PRODUCT CHANGE NOTIFICATION

#PCN-DCT-5D88-11

Business Unit	Product Line Code	Type of Change	Action	Date of issue
DCT	241	Mechanical	Notify Distributors and Field	09/07/2011

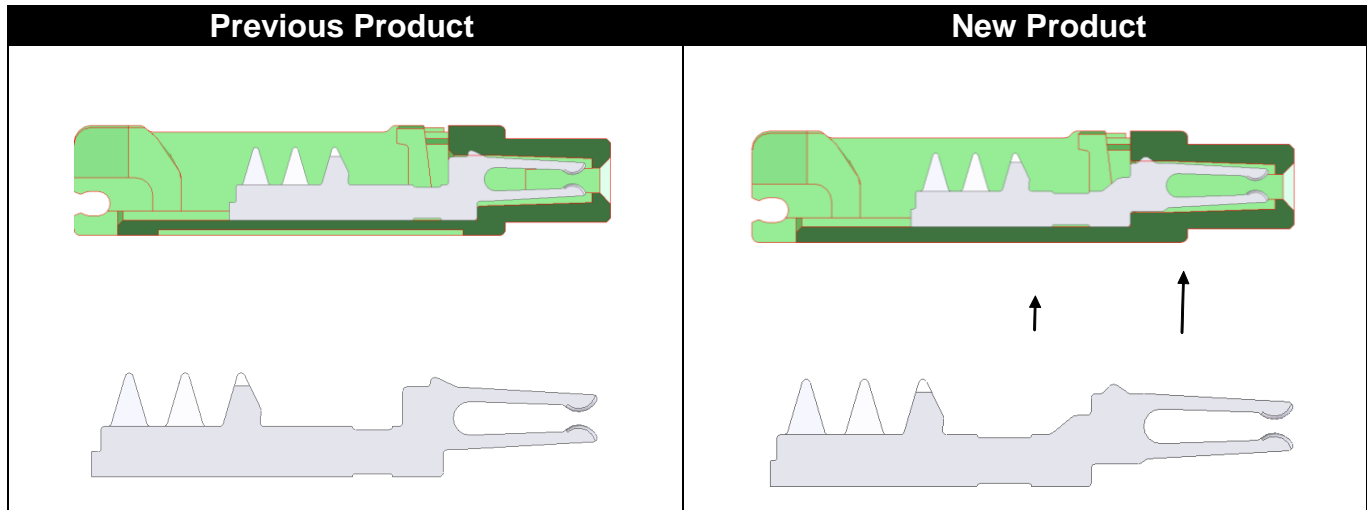
Due to our continuous improvement process, the following products will be delivered with a modified housing and blade as shown in the provided images. The backside pocket of the 4 and 8 pole versions will be removed. Furthermore the housing material will change from a PBT to PA. Current dimensions, approvals and technical data will remain the same. During the conversion period both versions will be delivered depending on the inventory.
